MANDATORY SERVICE BULLETIN

MSB 42-148/1

MSB 42NG-094/1

Replacement of the main landing gear (MLG) and nose landing gear (NLG) retaining rings.

Figure 2: NLG Retaining Rings

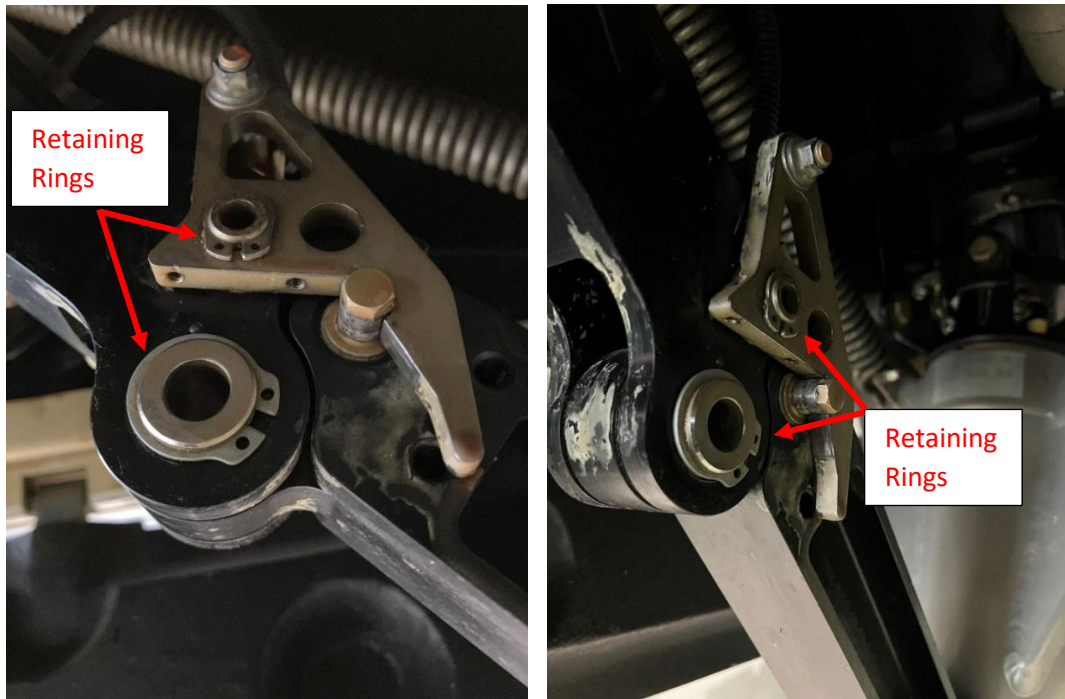
1	Pull and tag the GEAR circuit breaker to prevent inadvertent landing gear operation.
2	<p>Locate the retaining rings. See Figure 1 for MLG locations and Figure 2 for NLG locations.</p> <div style="display: flex; justify-content: space-around;">   </div> <p style="text-align: center;">Figure 1: MLG Retaining Rings</p>

3	Replace one retaining ring at a time.
4	Remove the retaining rings from the MLG legs and NLG leg as per the figures. (Refer to Figures 1 and 2 for location)
5	<p>CAUTION: Do not remove or move shafts while replacing retaining rings:</p> <p>Clean the grooves of the bearing shafts. Inspect the folding stay and bearing shafts for general condition before installing the new retaining rings.</p> <p>NOTE: If for any reason the folding stay, and/or the bearing shaft needs to be removed for repair / replacement / further inspection, perform work in accordance with AMM section 32-00, then proceed to step 6.</p>
6	<p>NOTE: Do not overstretch the retaining rings during installation. Open the rings only enough to fit over the shaft when installing.</p> <p>Install the new retaining rings. Make sure the retaining rings properly engage into the grooves of the bearing shafts.</p>
7	Clean working areas, check for foreign objects.

Quantity	Part Number	Description
4	DIN471-10-MZP	DIN 471-10x1.0-MZP, Retaining ring (MLG Brace Assy LH and RH)
4	DIN471-20-MZP	DIN 471-20x1.2-MZP, Retaining ring (MLG Brace Assy LH and RH)
2	DIN471-18-MZP	DIN 471-18x1.2-MZP, Retaining ring (NLG Brace Assy)
2	DIN471-10-MZP	DIN 471-10x1.0-MZP, Retaining ring (NLG Brace Assy)
